**RESOLUTION HOLDING PUBLIC HEARING ON APPEAL BY MILLER
VALENTINE GROUP OF THE DENIAL OF AN AMENDED SITE PLAN
“SOUTHRIDGE SENIOR LOFTS” AT 695 EAST ARMY POST ROAD**

Communication from the City Plan and Zoning Commission advising that at their meeting held October 15, 2015, the following action was taken regarding a request from Miller Valentine Group (developer) represented by Michael Athan (officer) for review and approval of an amended Site Plan "Southridge Senior Lofts" under design guidelines for multiple-family dwellings on property located at 695 East Army Post Road, to allow development of a 4-story, 52-unit multiple-family dwelling. The developer is seeking an alternate Crane Board insulated Vinyl siding in lieu of cement board siding as an exterior material. The subject property is owned by Macerich Southridge Mall, LLC.

RE: Southridge Senior
Planning Commission Appeal

A401

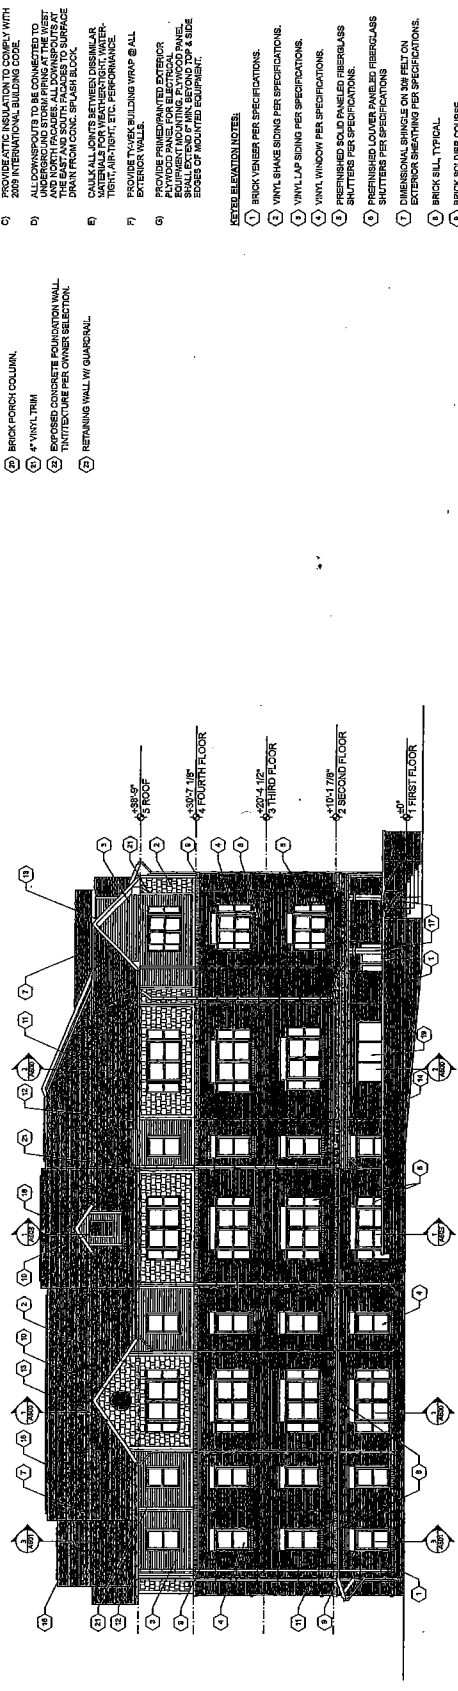
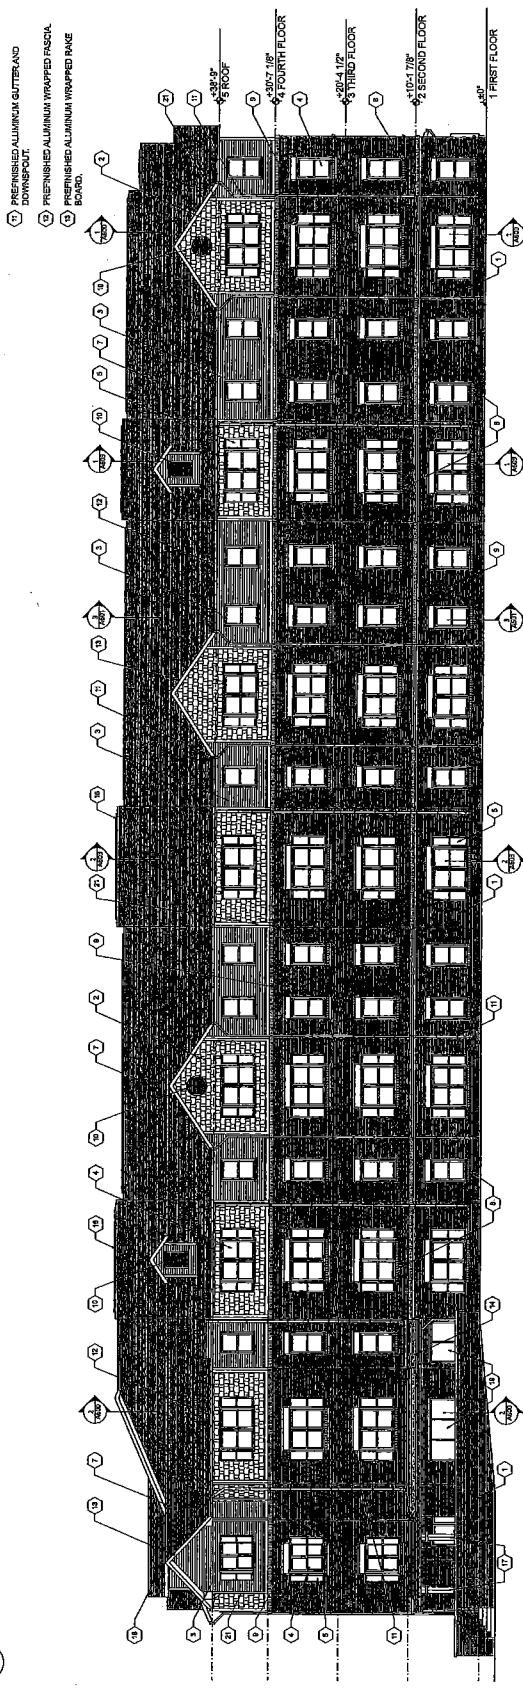
*The proposed apartment building is a 4-story structure with gabled roof features. Exterior materials proposed consist of brick, insulated Vinyl lap-style siding product, Cedar shakes, architectural asphalt shingles, and Vinyl windows. **Staff recommends that the non-brick exterior materials should consist of cement board siding material and cedar shake material as originally approved.** On the previous consideration, staff indicated that this would have been helpful in meeting eligibility for tax abatement requirements. It has since been approved by the City Council for Tax Increment Financing as a pass through under agreement with Southridge Mall. The tax abatement conformance was not the only rationale for staff's recommendation to require cement board siding. Staff also believes that the cement board is a more durable product in maintaining its aesthetic qualities on a large structure. Vinyl materials have proven to show distortion, warping and buckling in a fairly short period of time, while cement board material installed properly maintains its integrity and requires only painting after a more extended period of time.*

The facades oriented toward the south and east are proposed with three stories of full modular brick exterior material and a full-story of brick material on the north and west facades internal to the site. The overall proposed palette of materials is comparable to the nearest residential development to the west known as Sommerset, including the use of Vinyl material. The brick material has dark shades with the shakes and lap siding proposed with earthtone shades. The roof would be broken up with gabled dormer elements. Louver and faux shutter elements are proposed as decorative elements.

Erik Lundy presented the staff report and recommendation. He noted that Urban Design Review Board was very adamant about a substantial amount of brick going up three floors, which they are showing on the exterior public view sides. The back side had less of the brick material and more of what they were proposing as the Vinyl material. Staff and Plan and Zoning Commission approval state on August 6, 2015 recommended that the Vinyl they were proposing be replaced with hardi-cement board type of material.

1. Conformance with all administrative review comments of the Permit and Development Center.
2. **Changing the proposed insulated Vinyl lap siding material to a cement board material.**

Crane Board Lap Siding

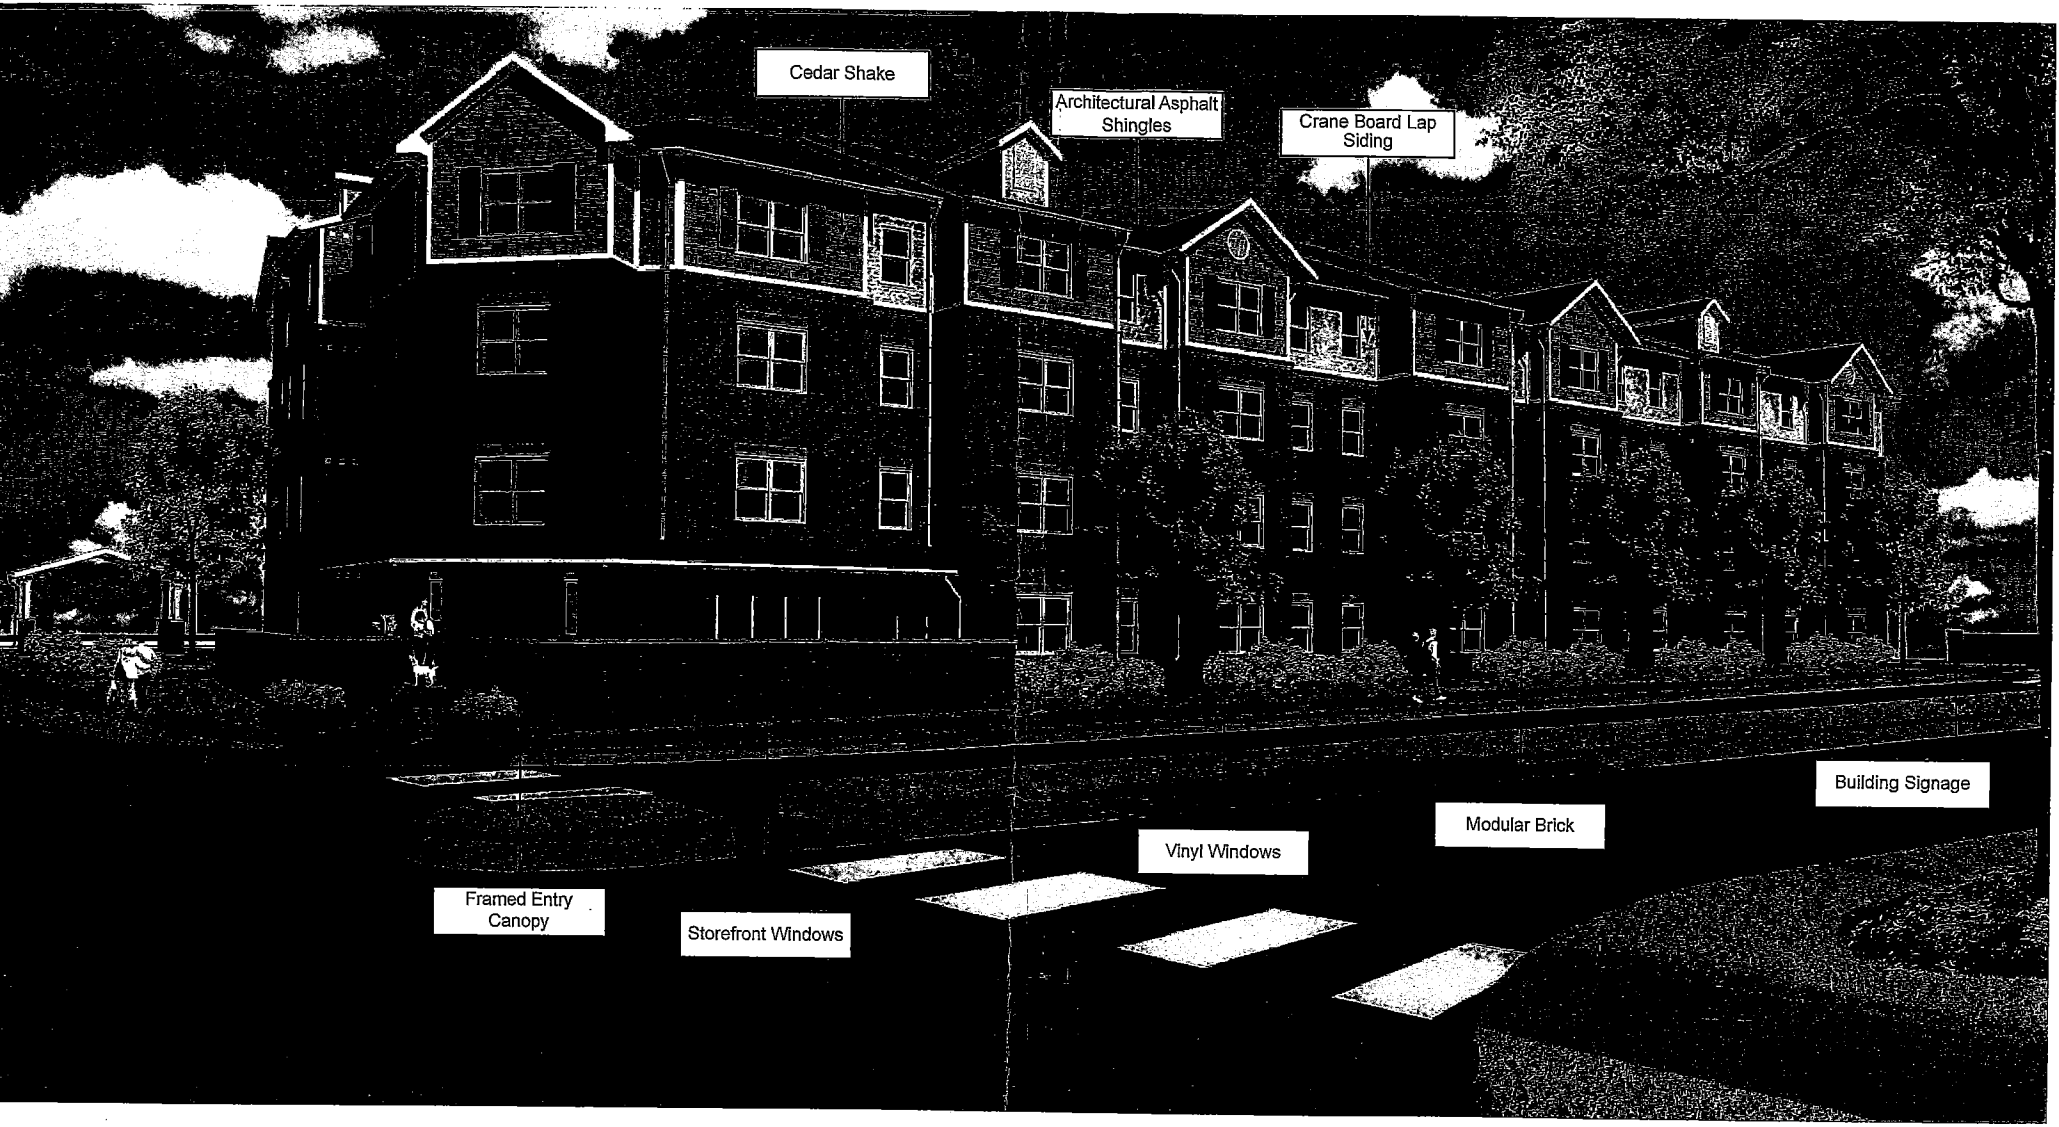
Mike Simonson stated that he believes Hardi-Plank is getting a little bit of a bum rap, just as any material it depends on how it is installed. Hardi-Plank is a very durable material if properly installed. He believes that the correct Vinyl siding is also a good material. He believes that this Commission has taken issue with Vinyl because of seeing a mil that is very thin and it is not stable. There is a lot of warping, discoloration from the sun. He likes this particular product because it is adhered to the insulation board which gives it rigidity and if you look at the thickness of the Vinyl it is a very heavy Vinyl. He thought the applicant was coming to the Commission asking for a substitution and now the applicant is telling us it's because he has seen poor experience with the Hardi-Plank. He thought the applicant was presenting his case tonight because of the insulated value. The energy code that has been adopted that is followed in Des Moines is much stricter and its added construction cost to buildings. It is not just about insulation but it is how insulation overlap studs which the sample product shown tonight does and does very well. He has no concerns with this material.

Will Page asked if the hardi-board on the photo shown would be the creamy color surfaces.

Mike Athan stated that was correct. The materials Commissioner Page is looking at on both photos you will see a note that says Crane and a note that says hardi-board. It's all the same façade. It is one material versus another from building to building. He agrees that hardi-board is a great product, they also found that the Crane Board held up just as well and

Will Page stated he believed Mr. Athan's discussion of the smooth surface of the Crane board and the texture of the Hardi-Plank was interesting. All of these things are trying to mimic weather board. Therefore, he believes that just in terms of the material being sleek isn't necessarily an admirable quality.
